STAFF RECOMMENDATION
1222 Villa Place
July 17, 2019

Application: New Construction—Addition and Outbuilding; Setback Determination
District: Edgehill Neighborhood Conservation Zoning Overlay
Council District: 17
Base Zoning: RS5
Map and Parcel Number: 10505000400
Applicant: Dustin Timmons, Builder
Project Lead: Sean Alexander, sean.alexander@nashville.gov

<p>Description of Project: An application to enlarge an historic house with a rear addition and to construct an outbuilding at the rear of the lot.</p> <p>Recommendation Summary: Staff recommends approval of the proposed addition with a setback determination and a detached outbuilding with the condition that all stone selections, roof colors, window and door selections are administratively approved prior to construction.</p> <p>Meeting those conditions, staff finds that the proposal meets the Edgehill Neighborhood Conservation Zoning Overlay design guidelines.</p>	<p>Attachments A: Photographs B: Site Plan C: Elevations</p>
--	--

Proposed Site Plan

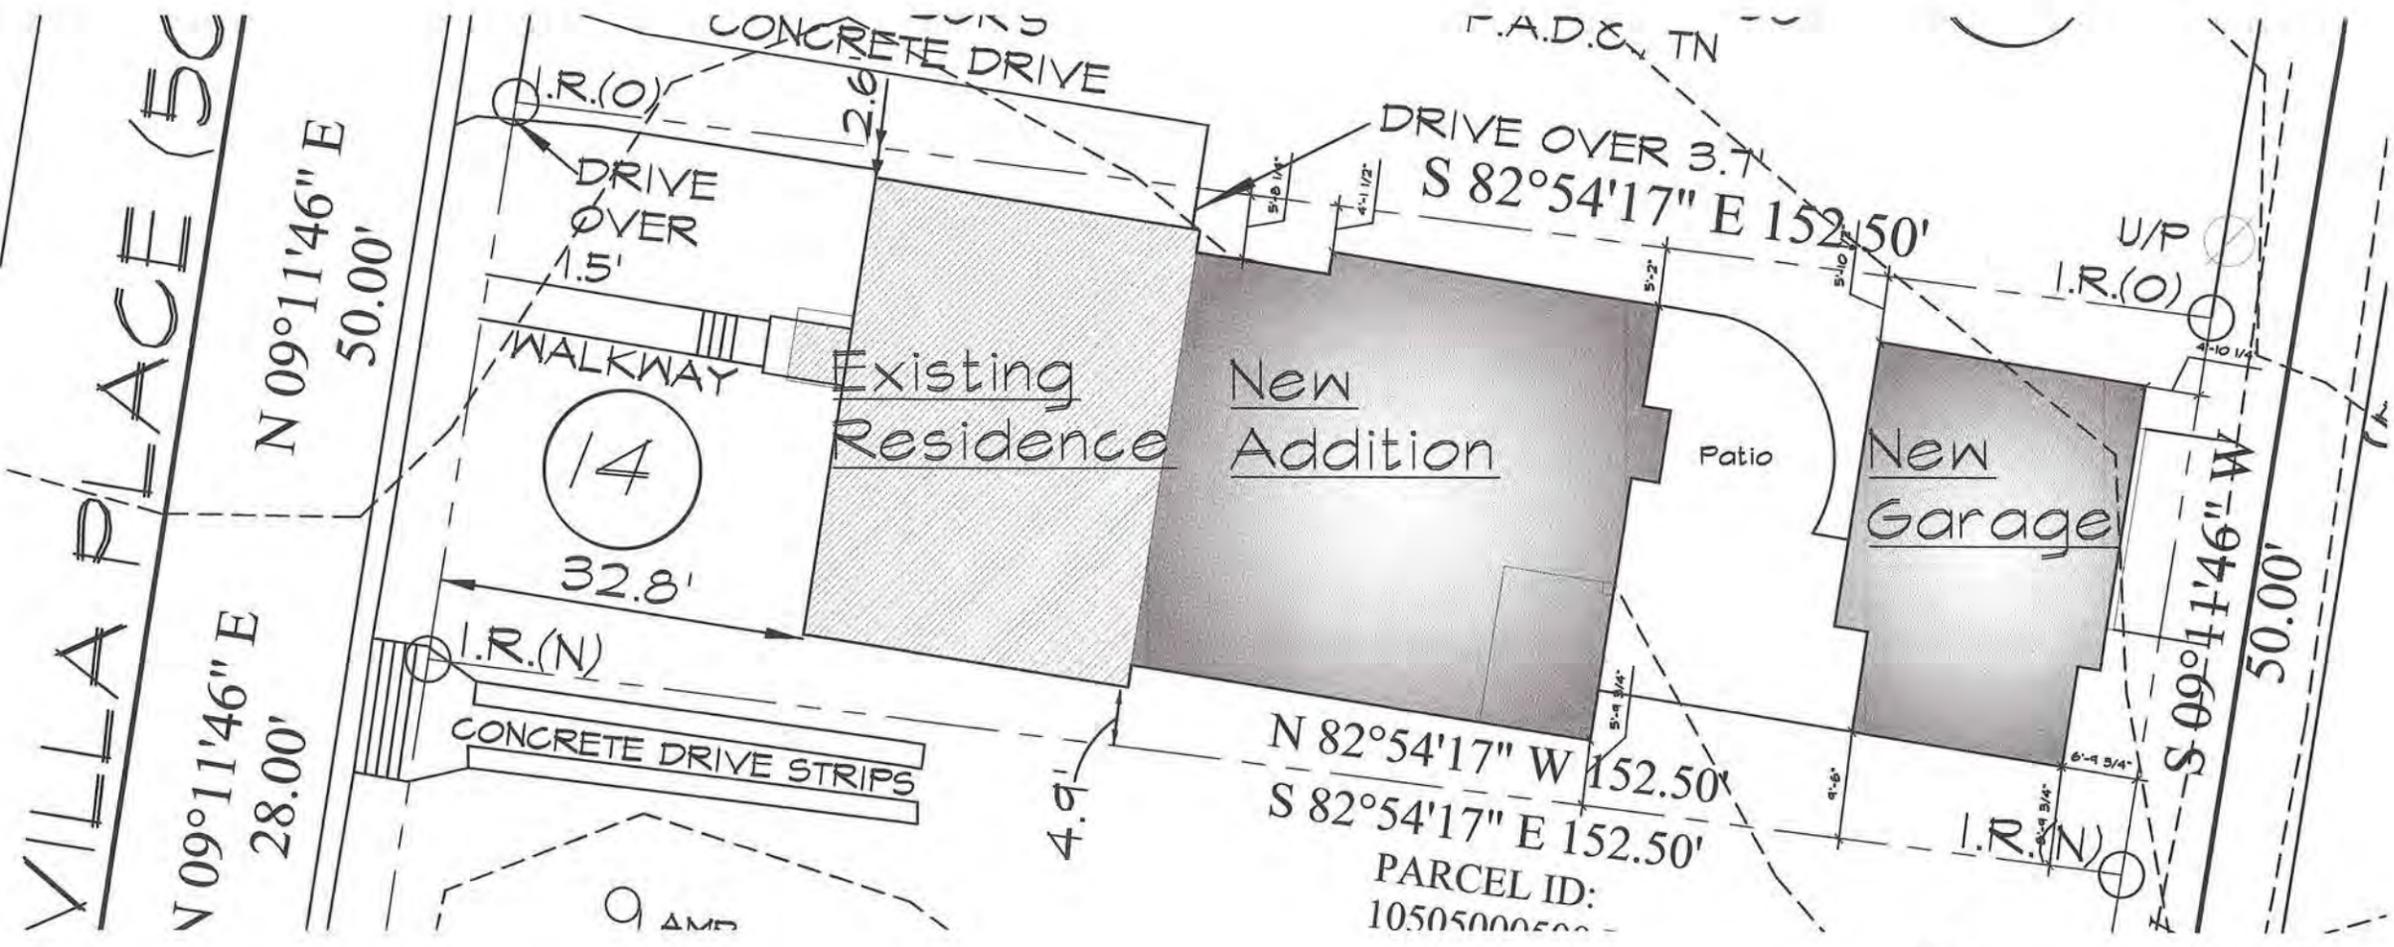
Setback & Rhythm of Spacing: The existing house is forty-one feet (41') wide and is slightly off-parallel with the long axis of the property, which causes portions of the house to be closer to the side property lines than the current setback regulations require. The addition will match the width of the historic house on the left side and will be stepped in two feet (2') from the side of the house on the right. As a result, the proposed addition would also encroach on the standard setback buffers required today.

The site plan shows a setback of four feet, ten and one quarter inches (4'-10 ¼"), however the applicant has agreed to adjust this to meet the standard five foot (5') rear setback. Staff finds that the location and setbacks for the proposed outbuilding will be appropriate and that the proposal meets Section IV.E of the design guidelines.

Staff finds that the proposed shorter setbacks are compatible with the historic house and are appropriate because of the house's width and orientation, and that the project will meet will meet Section III.C. of the Edgehill design guidelines for setback and rhythm of spacing.
